**Victorian Planning Authority**

Cardinia Shire Council  
Planning Scheme Amendment C 232  
Officer Precinct Structure Plan

Review of  
GHD report # 75469 dated 31 July 2018  
draft

Figure 1 GHD 2018 report – Figure 6

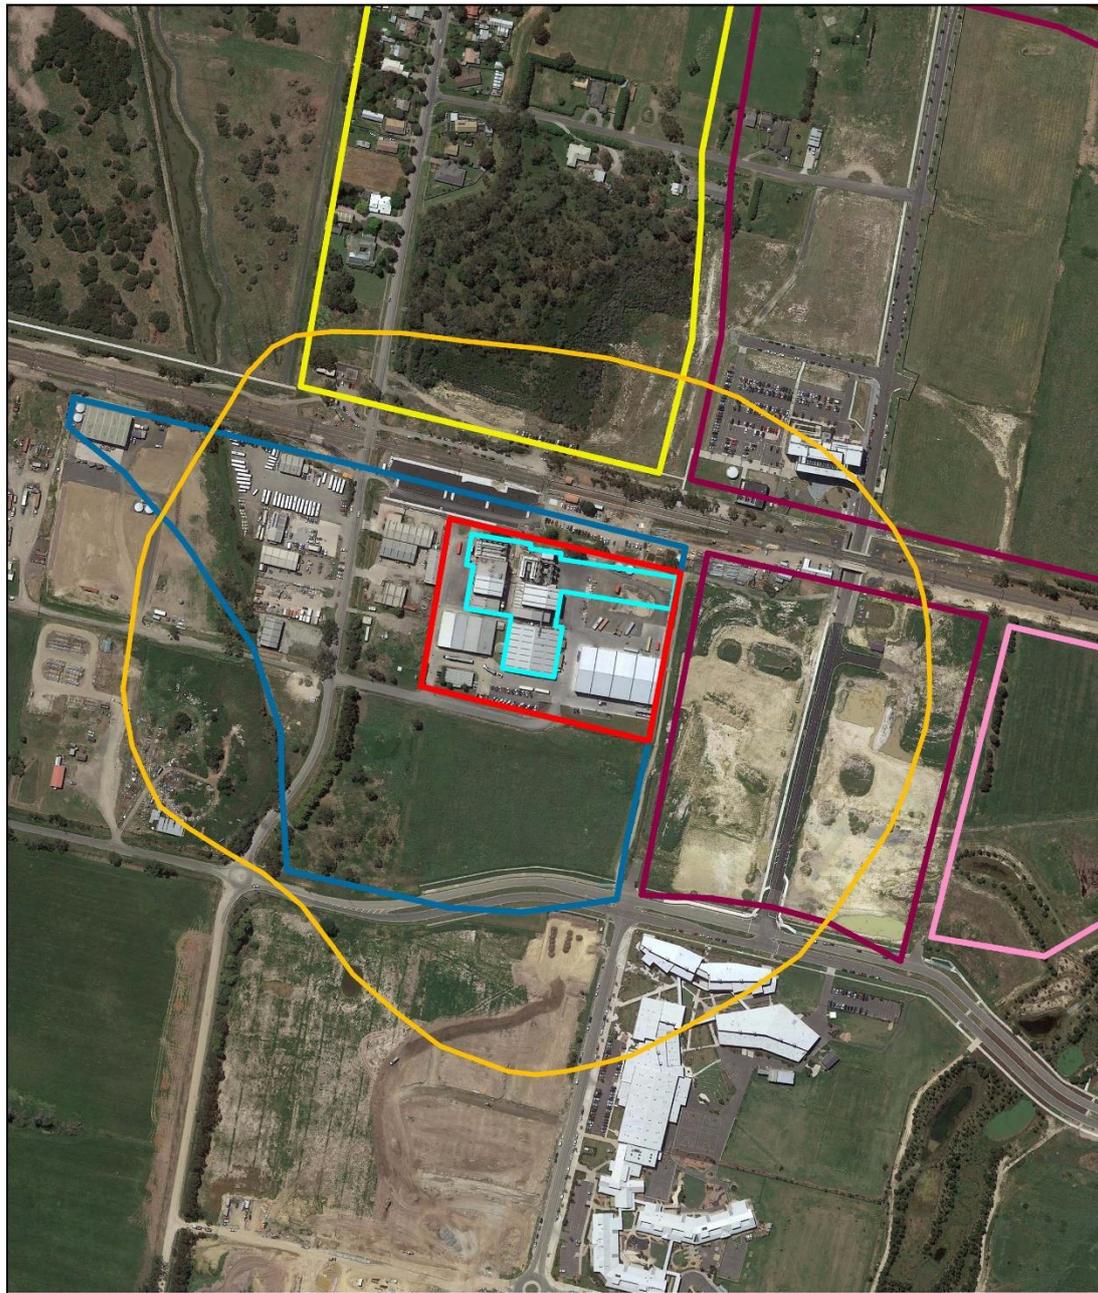
Figure 6 of the report (see below) shows that the 250 m directional buffer throws the following constraints on the nearby sub precincts:

- On the local business sub precinct where all but the western margin is constrained;
- On the mixed use sub precinct where from 60 m to 80 m of the southern margin is constrained;
- On the Core sub-precinct where almost the complete area of the parcel bordering the east margin of Hy Gain is constrained, and
- No constraint on the residential sub precinct further east of Hy Gain.
